PREVOST

WARRANTY BULLETIN

WB13-77

DATE :	NOVEMBER 2013	SECTION :	22 - HVAC
EXPIRATION:	NOVEMBER 2015		
SUBJECT :	PRE-HEATING SYSTEM THERMOSTAT REPLACEMENT

Figure 1 : Location of the thermostat to be replaced, in the evaporator compartment

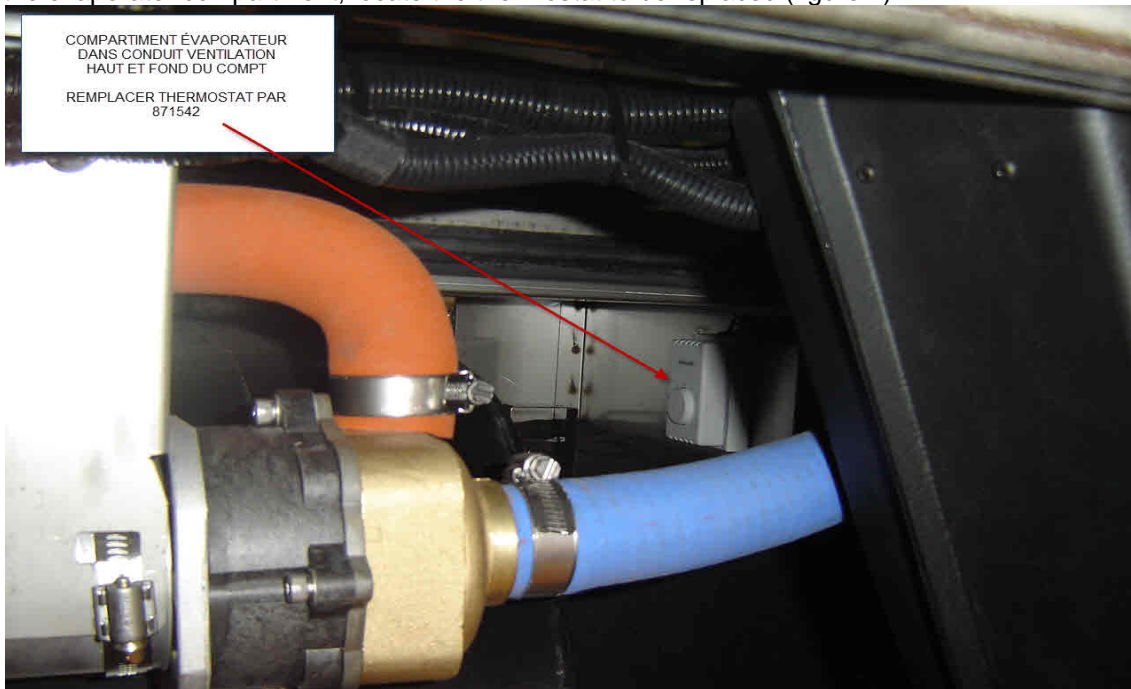
1. In the evaporator compartment, locate the thermostat to be replaced (figure 1).

Figure 2

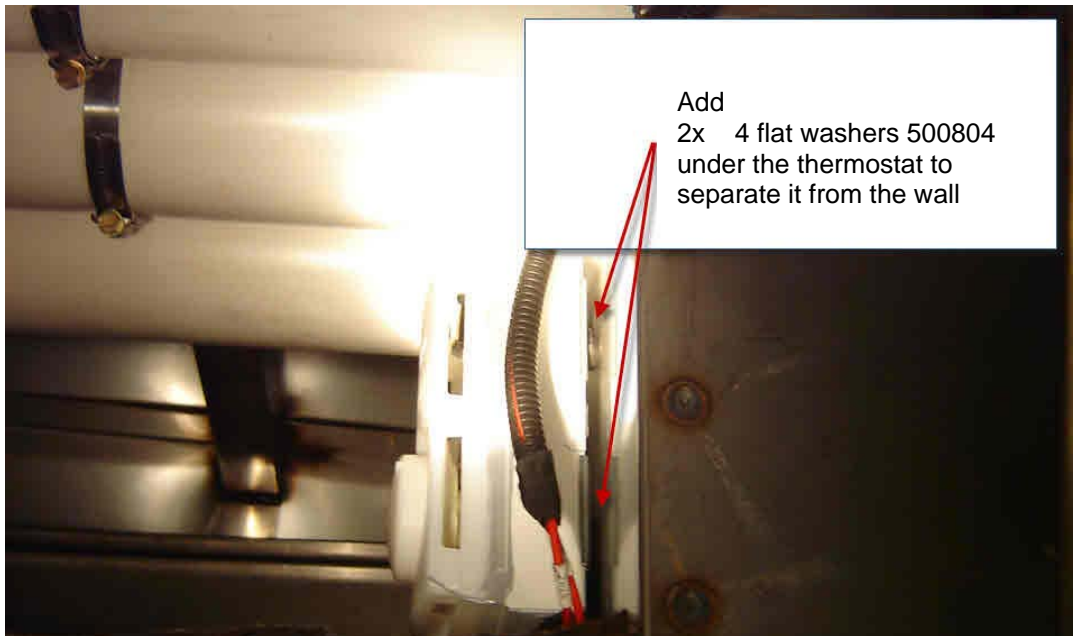
2. Replace the thermostat and add 500804 flat washers (figure 2).
